Easton Staff Development Review MEETING AGENDA

- b. **Application Number:** 2026 - 1699 / ESDR 26 - 05
Applicant: Rauch Inc.
on behalf of Building African American Minds Inc. (BAAM)
Location: 406 Moton Street
Tax Map 0104, Grid 00EA, Parcel 1367B
Zoning District: R-7A
Request: Sketch site plan review for site improvements with associated stormwater management facilities and other facility improvements.

Sketch Site Plan Review #1

BAAM - MOTON
ESDR Submission 02
05-06-2026

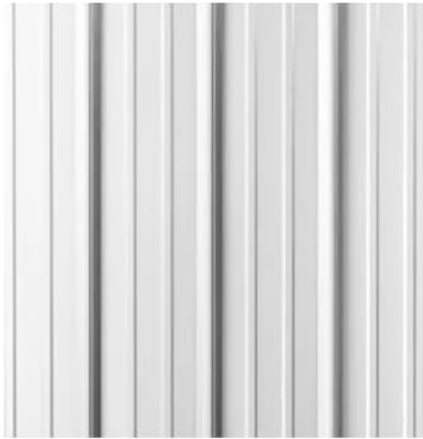
11. Architectural rendering has trees shown in the ROW (Pit Lane). Please revise.

Rauch Response: Correction made. Added comments for removal to proposed site demolition.

SHEET NO.:
C-101

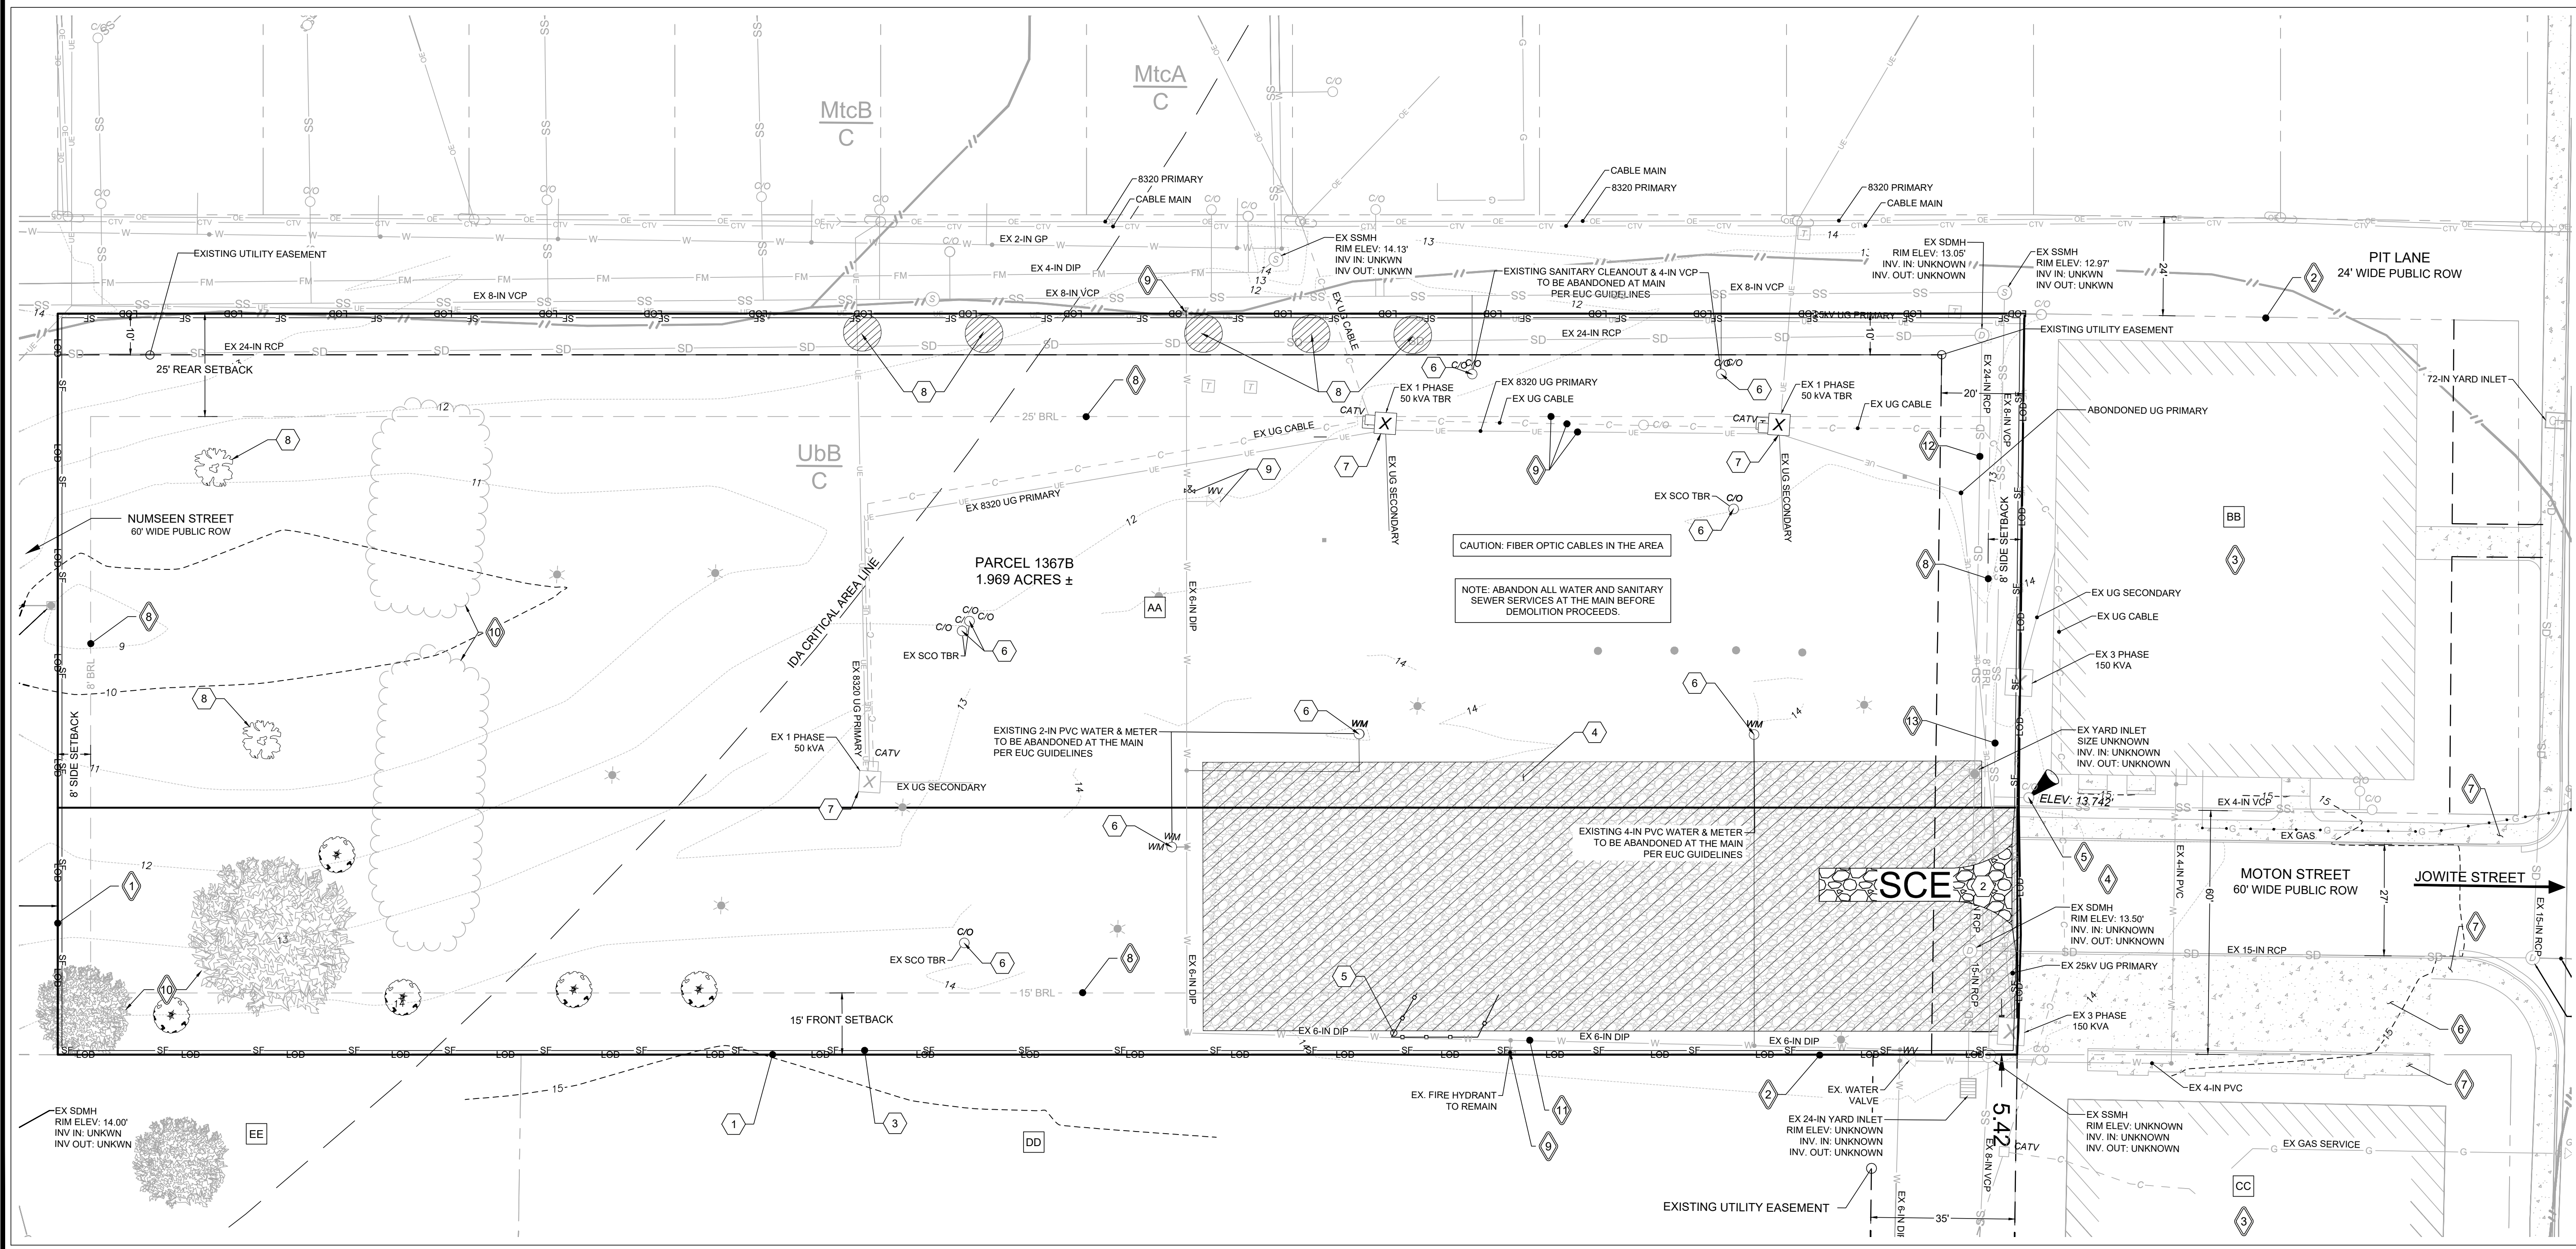
11. The landscaping shown on the Overall Site Plan, sheet C-101, does not match with the Illustrative Landscape Plan, sheet L-100. Verify and revise applicable plans.

Rauch Response: Correction made.

SHEET NO.:
L-101

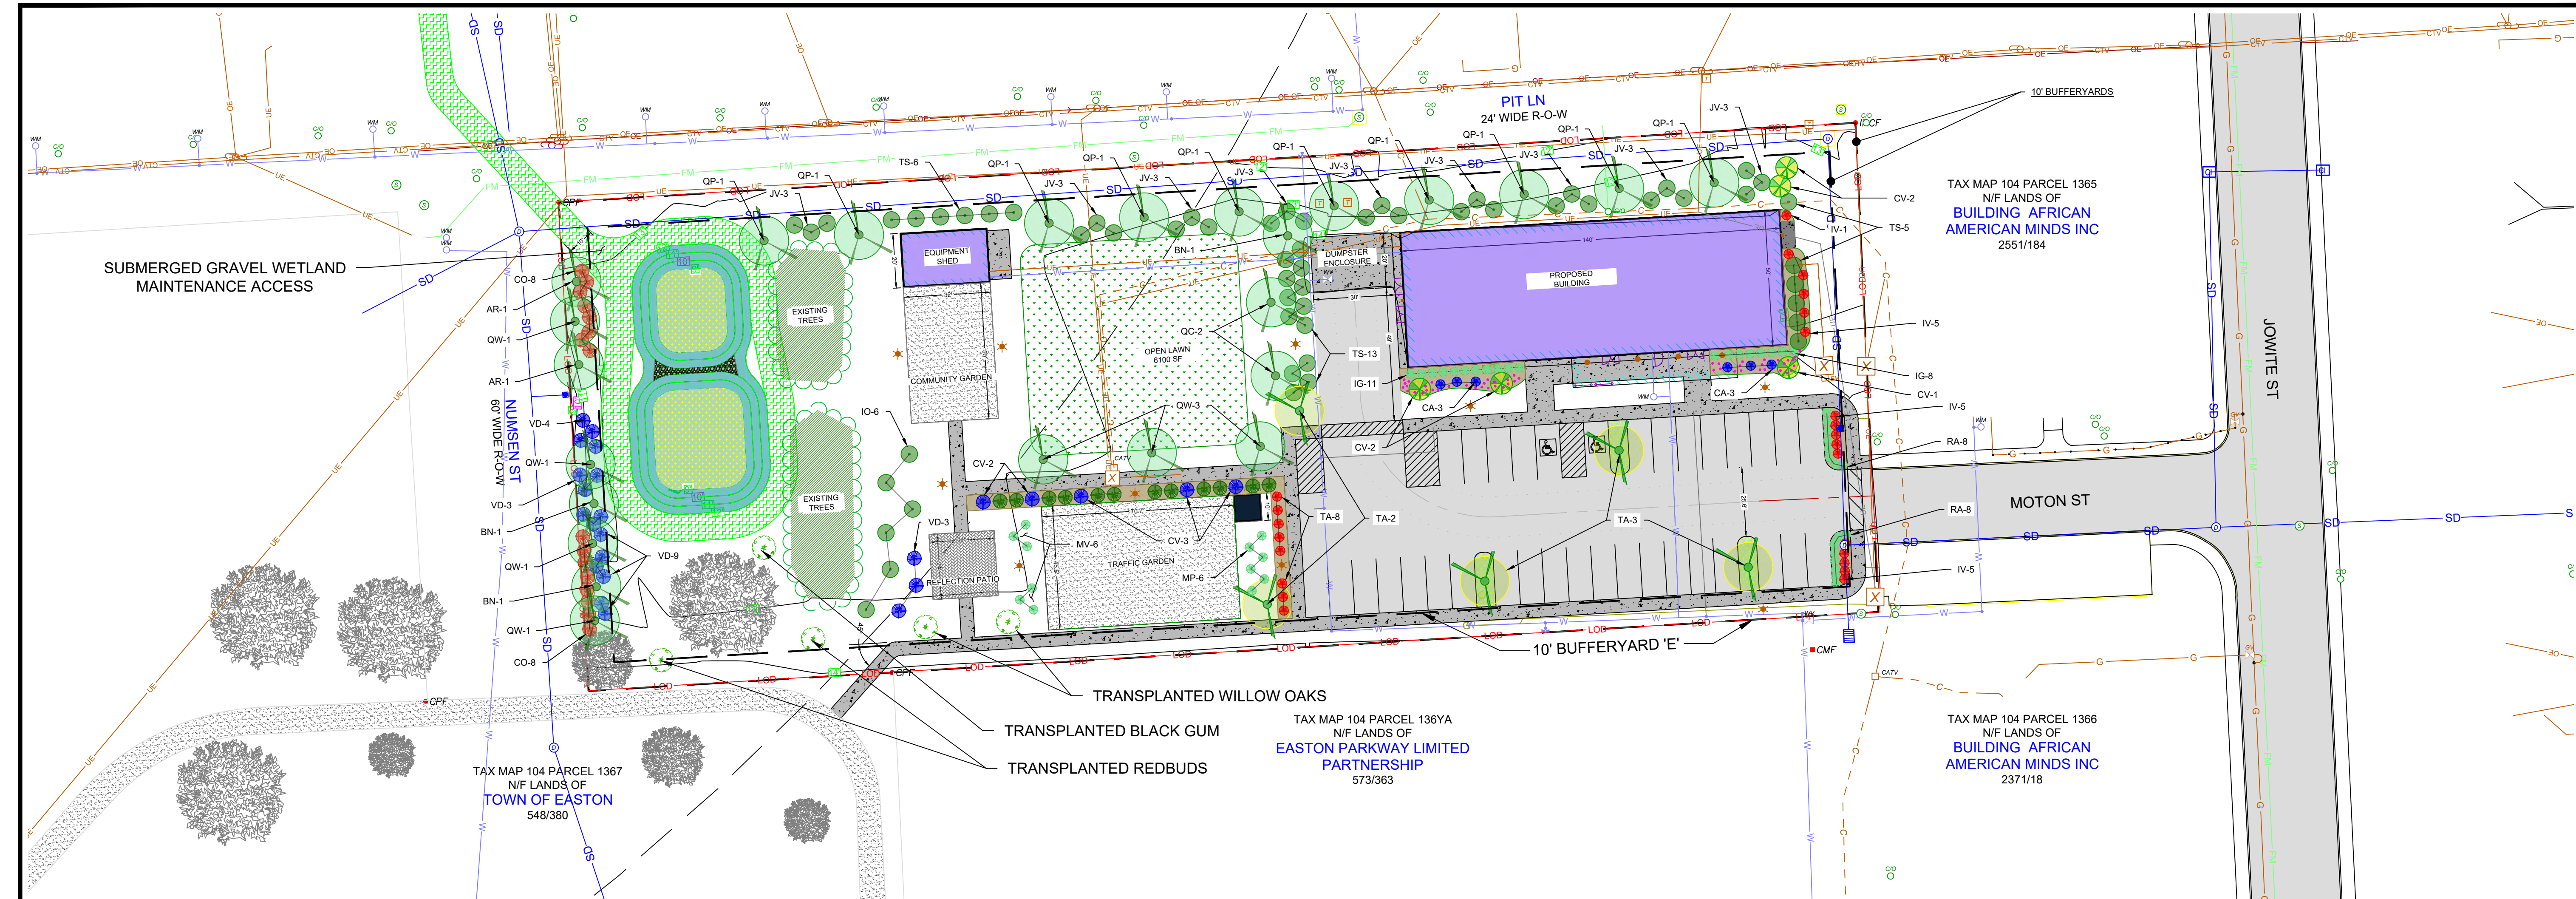
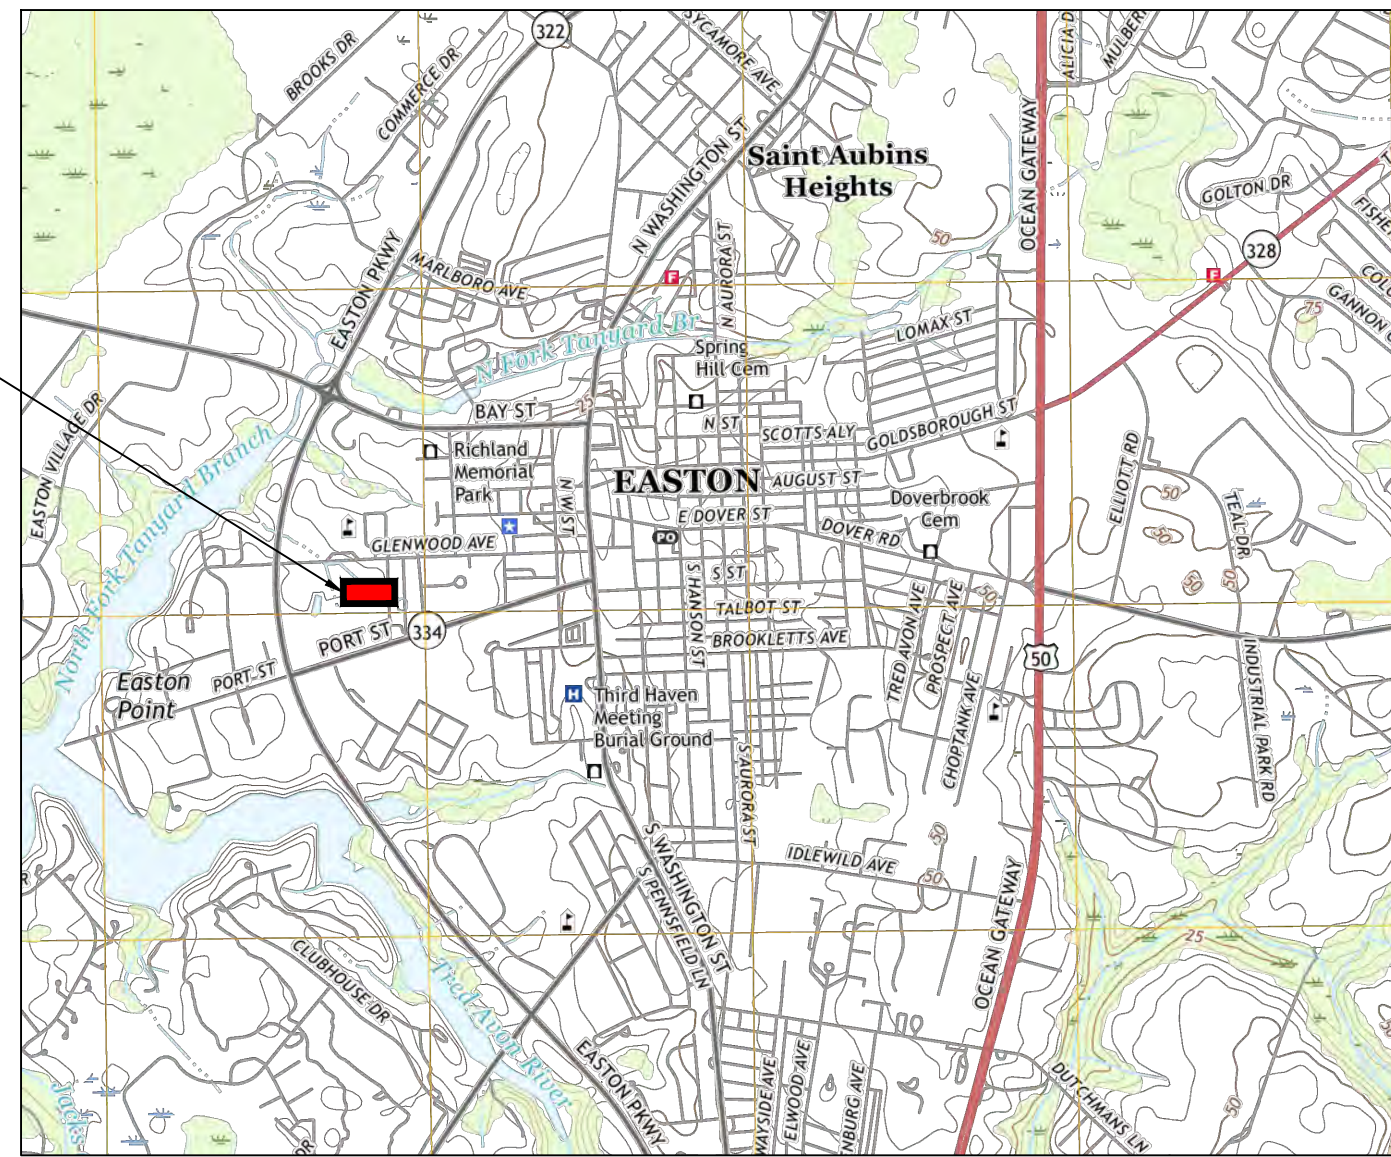
10. On sheet L-100, check the number count of plant material shown within the plant list and verify the labeling on the plan view. The plan view shows plant symbols that overlap. Please revise the plan to correct this issue.

12. There's a landscape island depicted on the Illustrative Landscape Plan, sheet L-100, blocking the entrance to the proposed overhead door vehicle access. Please remove it.

Rauch Response: Correction made.

Rauch Response: Correction made.
